## ARCHITECTURAL REVIEW BOARD STAFF REPORT

| <b>Project #/Name</b>        | <b>ARB-2026-00008: Veterinary Emergency Group</b>                                                                                                                                                                                                                                        |
| <b>Review Type</b>           | Site Plan Amendment                                                                                                                                                                                                                                                                      |
| <b>Proposal</b>              | To construct a veterinary clinic with associated site improvements.                                                                                                                                                                                                                      |

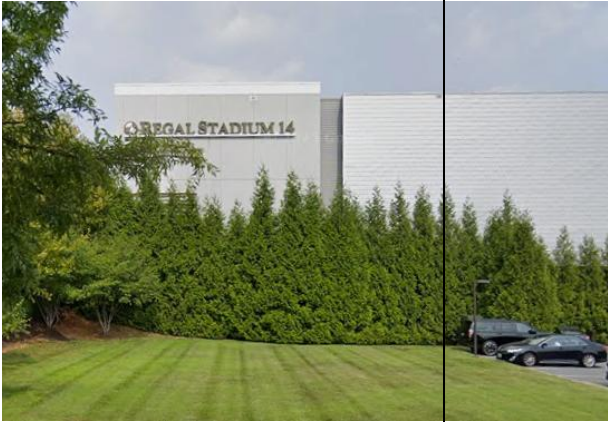
|    | and forms which may be embodied in architecture which is contemporary as well as traditional. The Guidelines allow individuality in design to accommodate varying tastes as well as special functional requirements.                                                                                                                                                                                                                                                                                                                                                               | material changes on this elevation appear random. They have no relationship to the rooftop screen, which is thoughtfully integrated                                                                                                                                                                                                                                                                                                                                                                                                  |  | the site and landscape plans show no plants or planting area for the screens.                                                                                                                                                                                                                                                                                                                                    |       |

| REF | GUIDELINE                                                                                                                                                                                                                                                                                                                                                                                                                                                                                                                                                                                                                                                                           | ISSUE 5/26/26                                                                                                                                                                                                                                                                                                                                                                                                                                                                                                                                                                                                                                                                                                                                                                                                                                                                                                                                                                                    | RECOMMENDATION 5/26/26                                                                                                                                                                                                                                                                                                                                                                                                                                                                                                                                                   | ISSUE 7/6/26                                                                                                                                                                                                                                                                                                                                                                                                                                                                                                                                                                                                                                                                                                                                                                                                                                    | RECOMMENDATION 7/6/26                                                                    |
|-----|-------------------------------------------------------------------------------------------------------------------------------------------------------------------------------------------------------------------------------------------------------------------------------------------------------------------------------------------------------------------------------------------------------------------------------------------------------------------------------------------------------------------------------------------------------------------------------------------------------------------------------------------------------------------------------------|--------------------------------------------------------------------------------------------------------------------------------------------------------------------------------------------------------------------------------------------------------------------------------------------------------------------------------------------------------------------------------------------------------------------------------------------------------------------------------------------------------------------------------------------------------------------------------------------------------------------------------------------------------------------------------------------------------------------------------------------------------------------------------------------------------------------------------------------------------------------------------------------------------------------------------------------------------------------------------------------------|--------------------------------------------------------------------------------------------------------------------------------------------------------------------------------------------------------------------------------------------------------------------------------------------------------------------------------------------------------------------------------------------------------------------------------------------------------------------------------------------------------------------------------------------------------------------------|-------------------------------------------------------------------------------------------------------------------------------------------------------------------------------------------------------------------------------------------------------------------------------------------------------------------------------------------------------------------------------------------------------------------------------------------------------------------------------------------------------------------------------------------------------------------------------------------------------------------------------------------------------------------------------------------------------------------------------------------------------------------------------------------------------------------------------------------------|------------------------------------------------------------------------------------------|
| 1   | The goal of the regulation of the design of development within the designated Entrance Corridors is to insure that new development within the corridors reflects the traditional architecture of the area. Therefore, it is the purpose of ARB review and of these Guidelines, that proposed development within the designated Entrance Corridors reflect elements of design characteristic of the significant historical landmarks, buildings, and structures of the Charlottesville and Albemarle area, and to promote orderly and attractive development within these corridors. Applicants should note that replication of historic structures is neither required nor desired. | <p>The proposed building does not have a strong relationship to the historic architecture of the county. As viewed from the Entrance Corridor, it has a minimal connection to the surrounding context of the shopping center, but that could be significantly enhanced.</p> <p>The form and mass of the building are compatible with the other buildings in the shopping center. Proposed materials for the building elevations visible from the EC include EIFS in PPG “Delicate White” and Hardi siding. Those materials and the EIFS color are consistent with the previous approvals for the shopping center. However, the Hardi color is not identified on the drawings.</p> <p>The Entrance Corridor-facing elevation of the proposed building is mostly blank. It is divided into three unequal bays by material changes. The end bays are faced with EIFS and include no windows or doors. Between the EIFS is a bay with Hardi siding, a door, and two windows. The location of the</p> | <p>Revise the design of the south elevation to present an appropriate appearance for the Entrance Corridor, to eliminate the back of building character, and to coordinate better with similar sized buildings in the shopping center. Revisions to the location and treatment of bays, the position of window/door openings within bays, the relation between the roof screen and the bays, and the detailing of the bays are recommended. Revise side elevations to maintain coordination.</p> <p>Indicate the proposed color of the Hardi siding on the drawings.</p> | <p>The EC-facing elevation has been revised. It is now divided into 3 bays. End bays are faced with Hardie siding in “Sharkskin”. The center bay is EIFS in “Delicate White”. This revised distribution of materials provides a much more balanced appearance. The materials and colors are used throughout the town center. The lack of windows still identifies the elevation as the back of the building, but existing and proposed landscaping are expected to provide some mitigation. The revised design is consistent with the work session plans that the ARB felt were moving in the right direction.</p> <p>The east side elevation continues the EIFS walls and adds a composite plank siding detail above a door. The elevation also includes three green screens, which could help to improve scale and relieve blankness, but</p> | <p>Revise the plan to show planting area and plant selections for the green screens.</p> |
